ORIGINATION FORM •

Proposed Revisions to a Standard Plans Index

Index Number: 102-660 Sheet Number (s): 2 of 2 Index Title: Sidewalk Closure

PEDESTRIAN DETOUR INTO THE TRAVELED WAY - OPTION 1= (Temporary Barrier Shown, Low Profile Barrier Similar)

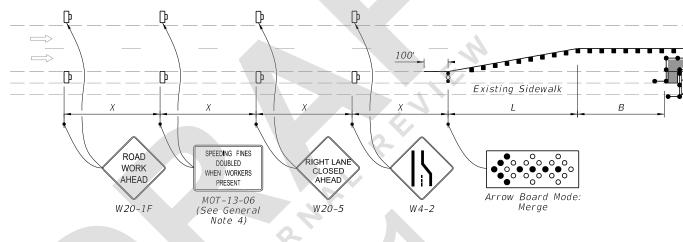
Sheet 2: Changed Note 4 - "work zone" to "work operations"; Added Note 5 - "Option 2 may only be used for work zone speeds of less than or equal to 35 mph and when called for in the Plans or as approved by an Engineer"; Changed title "TEMPORARY PEDESTRIAN WAY" to "PEDESTRIAN SPECIAL DETOUR"; Changed title "TEMPORARY PEDESTRIAN WAY DIVERTING TRAFFIC INTO THE TRAVELED WAY" to "PEDESTRIAN DETOUR INTO THE TRAVELED WAY - OPTION 1"; Added new detail "PEDESTRIAN DETOUR INTO THE TRAVELED WAY - OPTION 1"; Added new detail "PEDESTRIAN DETOUR
